**PLANNING COMMISSION
STAFF REPORT**

AGENDA ITEM: Planning File No. MAJ-23-0004: A sketch plan review of a multi-family residential development located at 411 Teller Street.

LOCATION: 411 Teller Street / LOTS 17, 18, & 19, BLOCK 19, FRISCO TOWN SUB

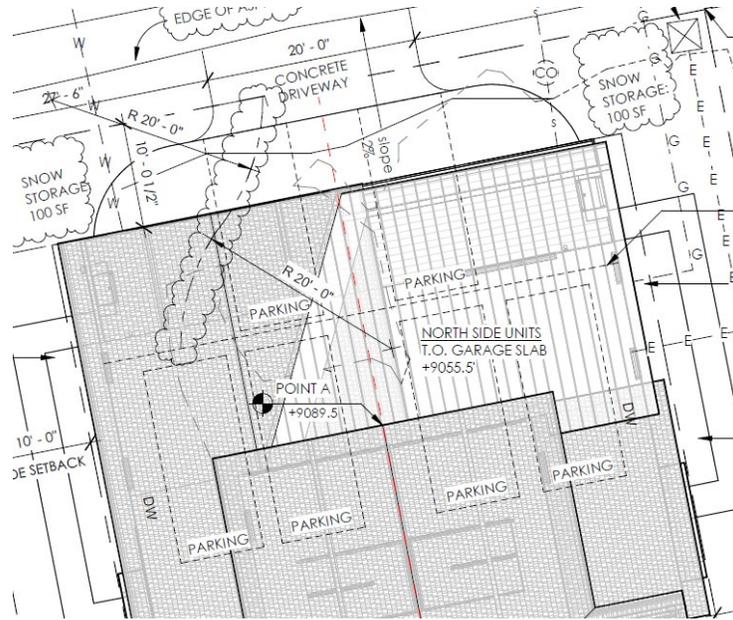
The applicant is proposing tandem parking for both buildings and has provided a turning radius analysis for one (1) of the parking spaces, shown below.

The applicant will be required to show compliance with two (2) out of four (4) of the above stated criteria at the final review of the Major Site Plan application. Staff recommends the Planning Commission take this opportunity to comment on the proposed parking of the site.

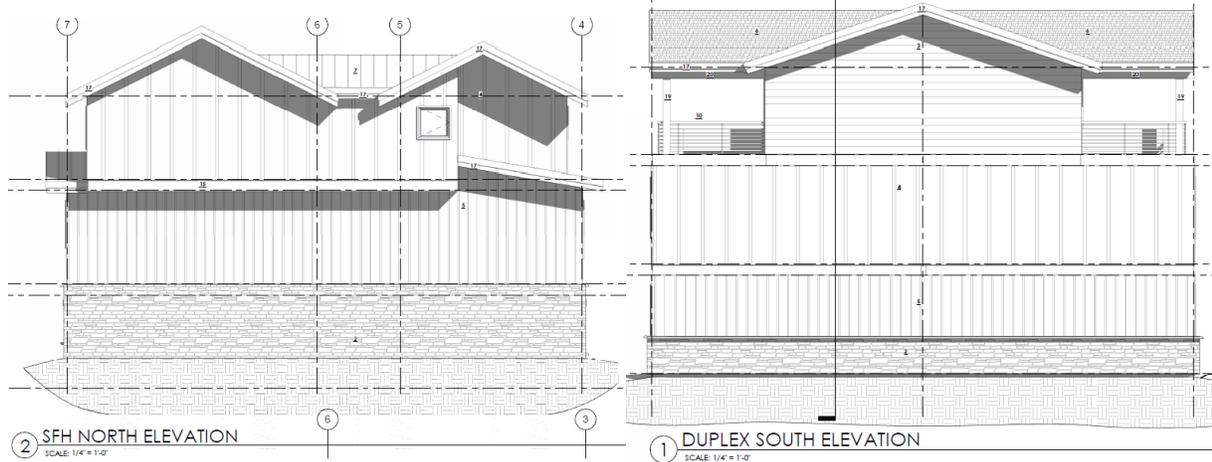
A variety of building elements are utilized on most facades of the building. The building elements utilized include: balconies, a change in materials and texture, variation in window sizes and shapes, and variation in roof forms. Staff found that there are two (2) facades not meeting the minimum standards: the duplex south elevation and the single unit north elevation. While these facades face each other, they are still required to meet the minimum requirements.

Staff recommends that the Planning Commission comment and discuss the intent of the façade design and the building elements utilized to show varied articulation.

Proposed bulk plane encroachment on north elevation.

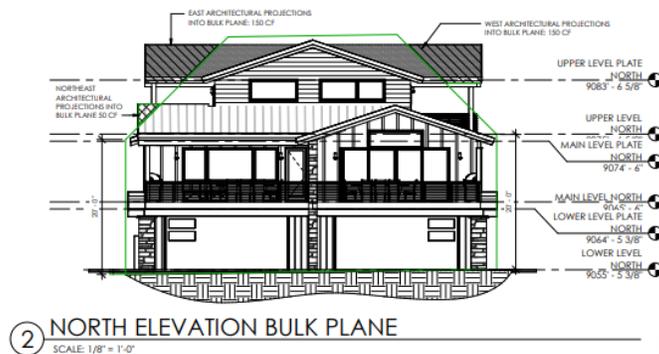
Bulk Standards (§180-6.23): Table 6-K of the UDC outlines bulk plane requirements. Building forms may deviate from the bulk plane standards if they do not exceed maximum building height and provide substantial architectural relief, with Planning Commission approval. The applicant is proposing 350 cubic feet of bulk plane encroachment.

Staff recommends that the Planning Commission comment on the proposed bulk plane encroachment and if they find that the proposed encroachments provide substantial architectural relief.
